Project	IEEE 802.16 Broadband Wireless Access Working Group < http://ieee802.org/16 >	
Title	Proposal to allow Extended Type subheaders for connections where ARQ is not enabled	
Date Submitted	2004-05-04	
Source(s)	Rehan Jalil Tassos Michail Mano Vafai Aperto Networks 1637 S. Main St., Milpitas, CA 95035, USA	Voice: + 1-408-719-9977 Fax: + 1-408-719-9970 mailto:rjalil@apertonet.com mailto:tmichail@apertonet.com mailto:mvfai@apertonet.com
Re:	802.16REVd/D4 Sponsor Ballot	
Abstract	The document proposes to allow the use of extended subheader type for connections where ARQ is not enabled.	
Purpose	To adopt the proposed changes during comment resolution procedure for sponsor ballot recirculation of 802.16-REVd/D4.	
Notice	This document has been prepared to assist IEEE 802.16. It is offered as a basis for discussion and is not binding on the contributing individual(s) or organization(s). The material in this document is subject to change in form and content after further study. The contributor(s) reserve(s) the right to add, amend or withdraw material contained herein.

Proposal to allow Extended Type subheaders for connections where ARQ is not enabled

Figure 1: Example of incorrect reassembly for non-ARQ connection using 3-bit FSN

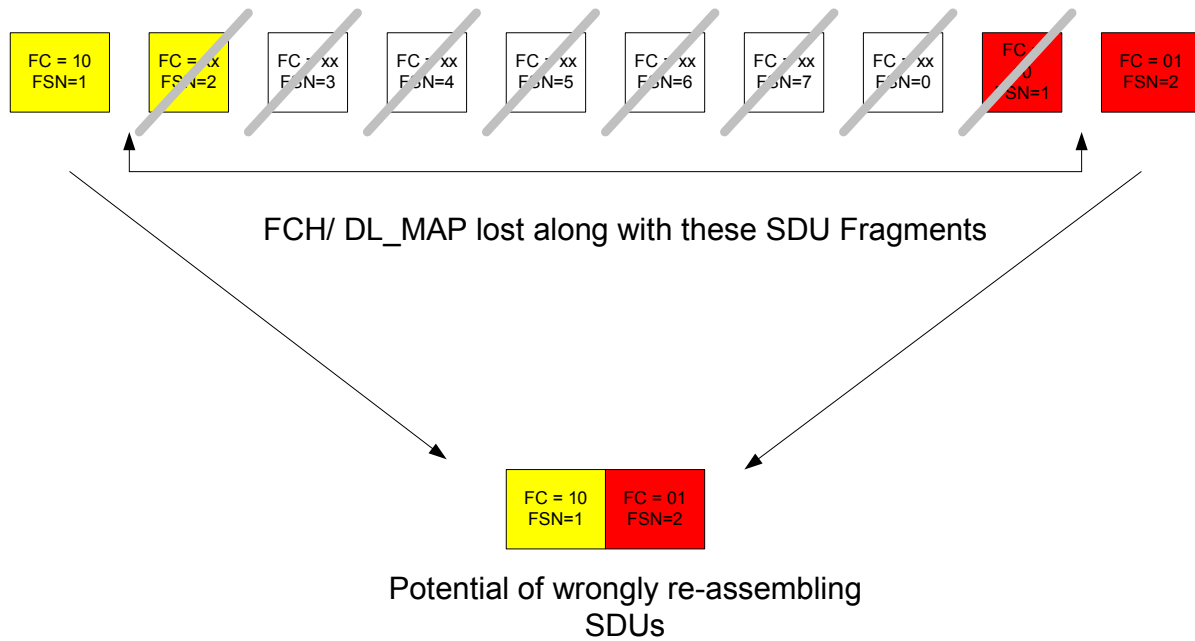
We next illustrate with an example how incorrect reassembly of an SDU may occur if a 3-bit FSN is used. In the scenario shown in Figure 1, 8 consecutive fragments are lost due to a lost FCH/DL-MAP and as a result the FSN wraps-around and causes incorrect reassembly. Given that Ethernet frames do not have CRC, such errors would cause significant performance degradation of upper layer protocols (such as TCP, UDP etc).

In this section we propose some changes to the working group document (P802.16-REVd/D4) to allow the use of the Extended Type for connections where ARQ is not enabled. **The rationale is that 11-bit FSN practically eliminates the probability of the scenario shown in Figure 1.**
